WATTS BAR 1

TVA

PROPOSED CHANGE TO TECH SPECS AND BASES, MARKUP

REC'D W/LTR DTD 8/27/92...9209020348

Figure B 3.1.7-1 (page 1 of 1)
Control Bank Insertion vs. Percent RTP

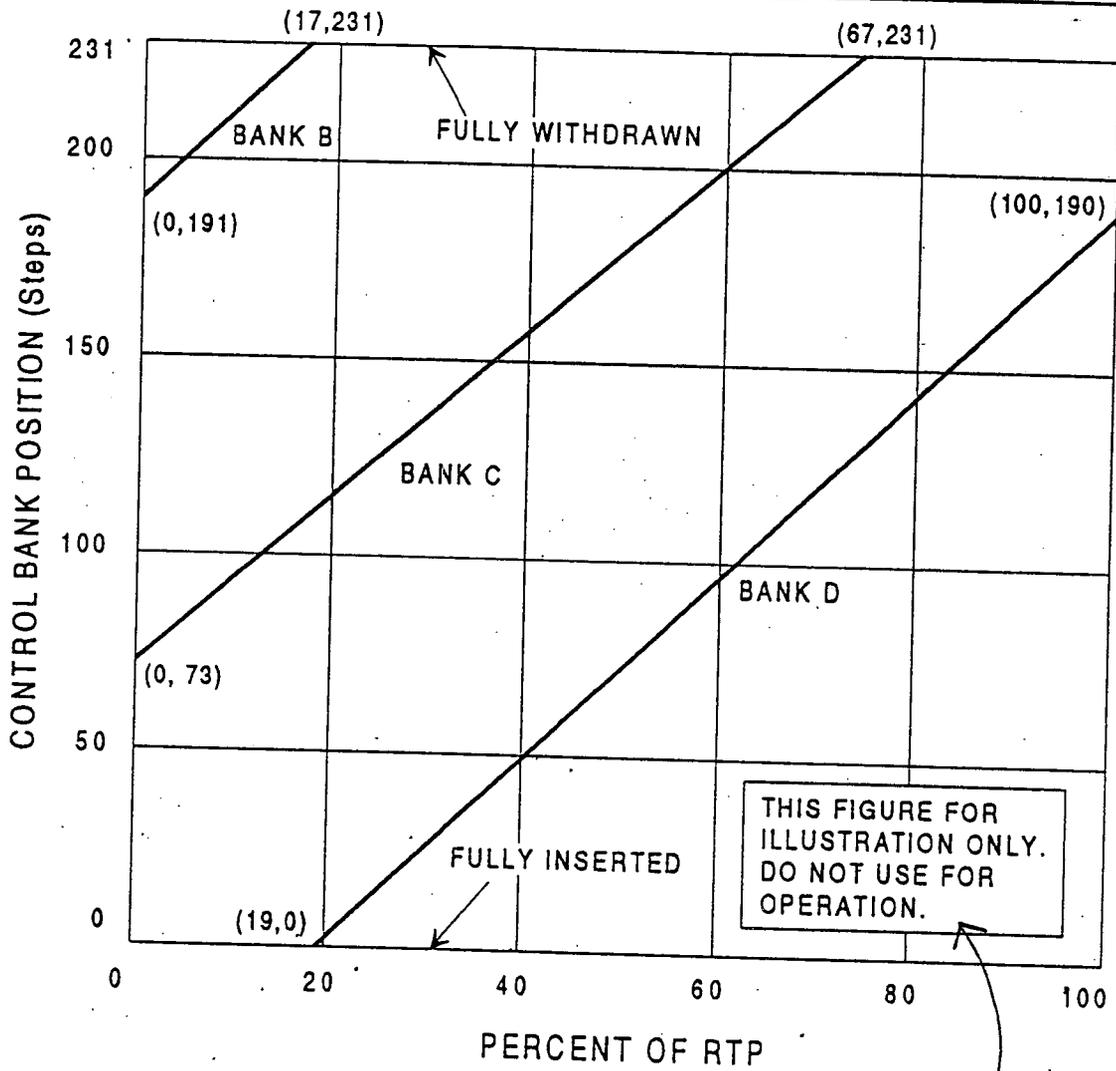
Replace figure
with INSERT from
Page B 3.1-41A

1. Change to correct error in STS.
2. Change to reflect WBN specific parameter values.
3. Change to reflect WBN specific control bank insertion figure.
4. Change in text to more clearly describe control bank overlap for control banks C and D at WBN.

Figure B 3.2.1B-1 (page 1 of 1) ③
 K(Z) - Normalized F_a(Z) as a Function of Core Height

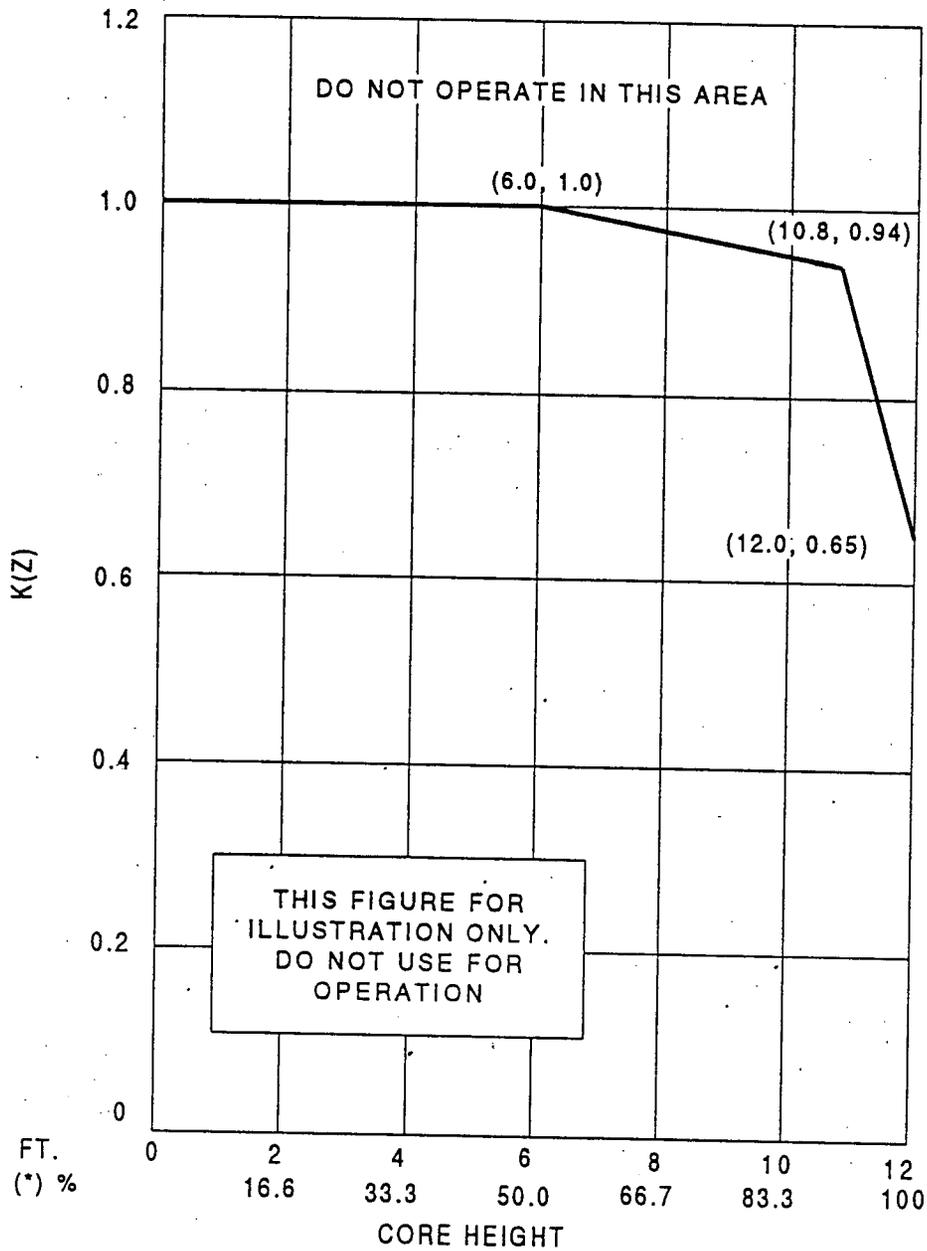
For this facility, the actual values of CFQ and K(Z) are given in the COLR; however, CFQ is normally a number on the order of [2.32], and K(Z) is a function that looks like the one provided in Figure B-3.2.1B-1.

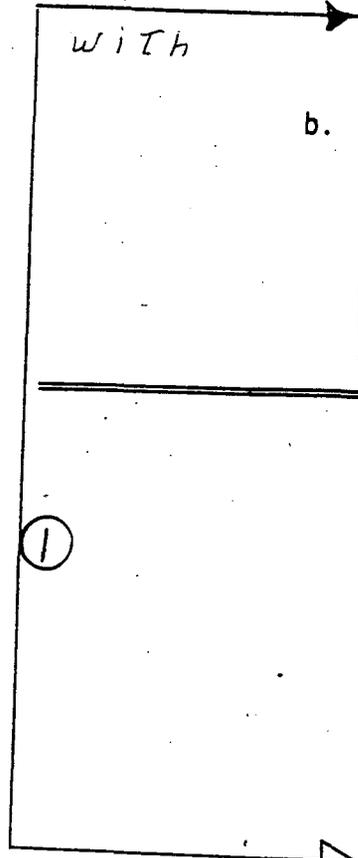
Replace with

a. Loss of voltage Allowable Value 16003 ± 69 volts with a time delay ~~of~~ ^{with 0.25 to 0.5 second time delay of} ¹⁵ for trip of the 6.9 kV shutdown board supply breaker.

Figure 3.4.16-1 (~~Page 1 of 1~~)

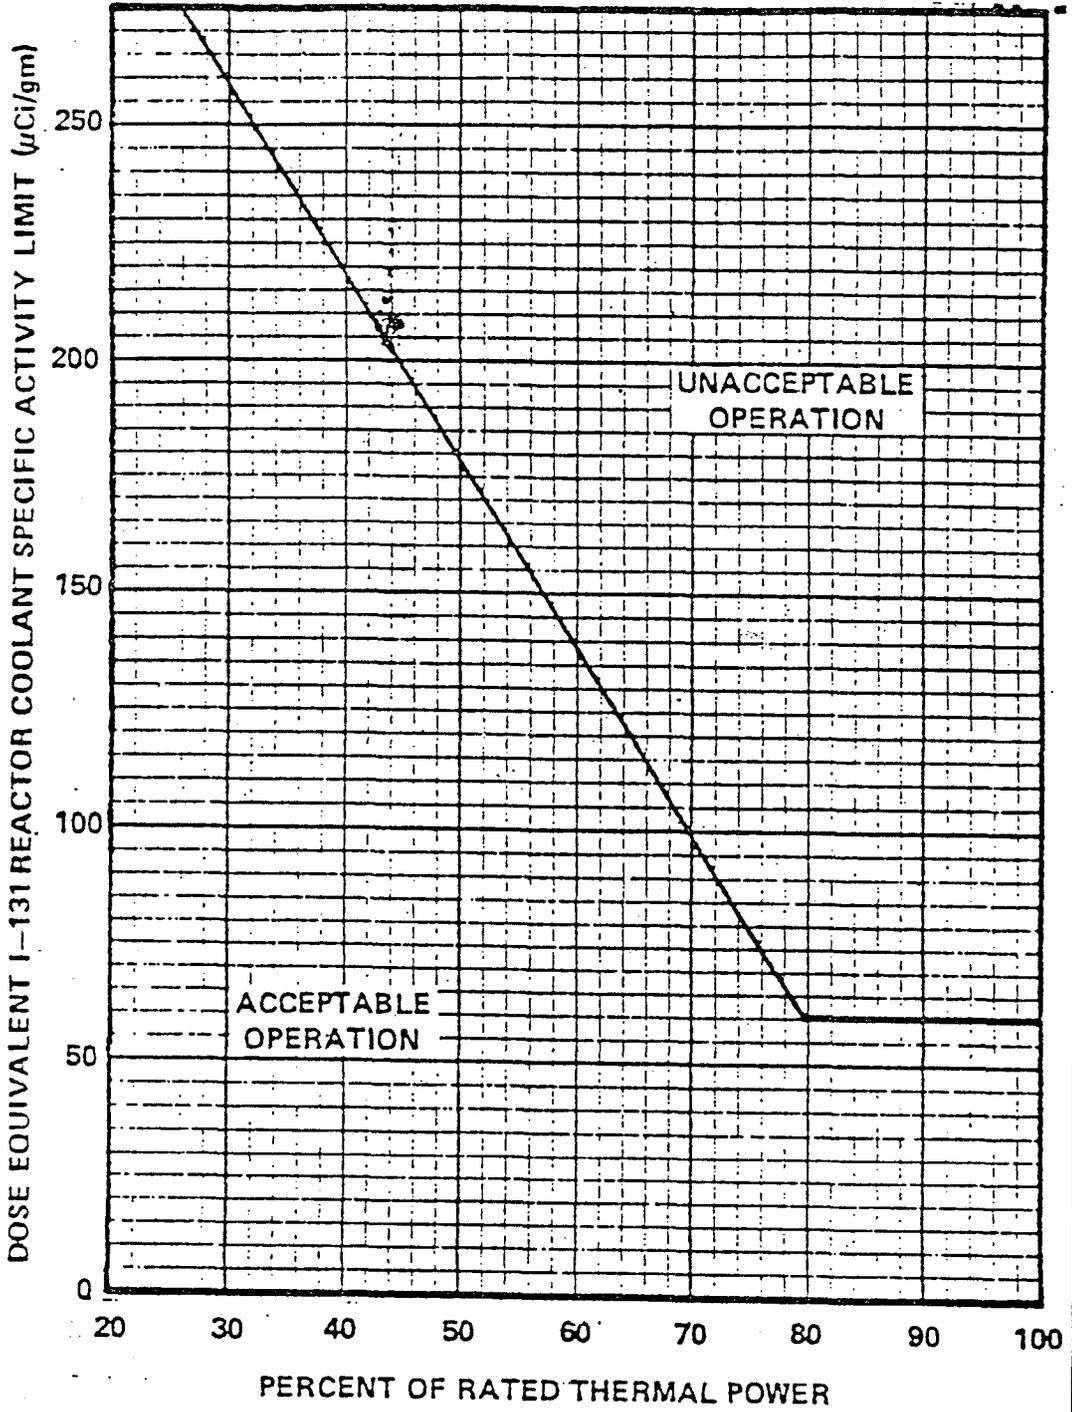
~~THIS PAGE IS A PLACEHOLDER FOR FIGURE 3.4.16-1~~
